# SOUTH BASCOM URBAN VILLAGE OPEN HOUSE (WORKSHOP #3) RE-DO FEBRUARY 15, 2018

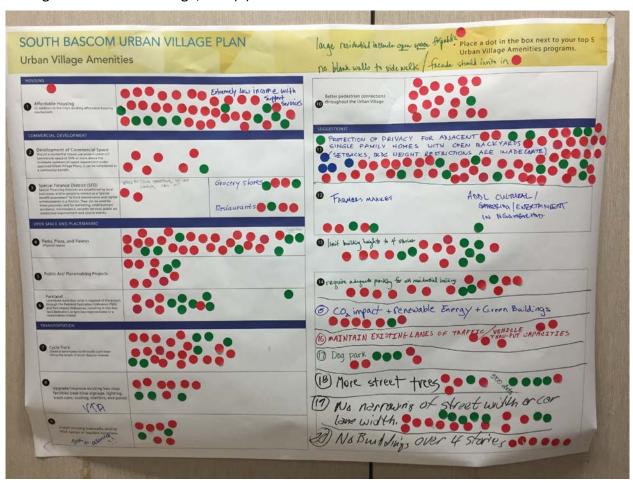
- Building heights do not respect single-family residential
- Respect the height, lower the daylight plans
- What about impacts to solar panels?

- Parking ratio / capacity do not allow reductions
- 130-foot building height at the San Jose Community College is out of character. There is too much height differential. The 130-foot height should be lowered to no more than 85 feet.
- Want larger setbacks from existing residential uses
- Taller fences or walls between properties paid for by developer
- Existing houses are typically only one-story tall
- Want daylight plane to start at the shared property line

Answer: The daylight plane allows for sun to reach the adjacent properties
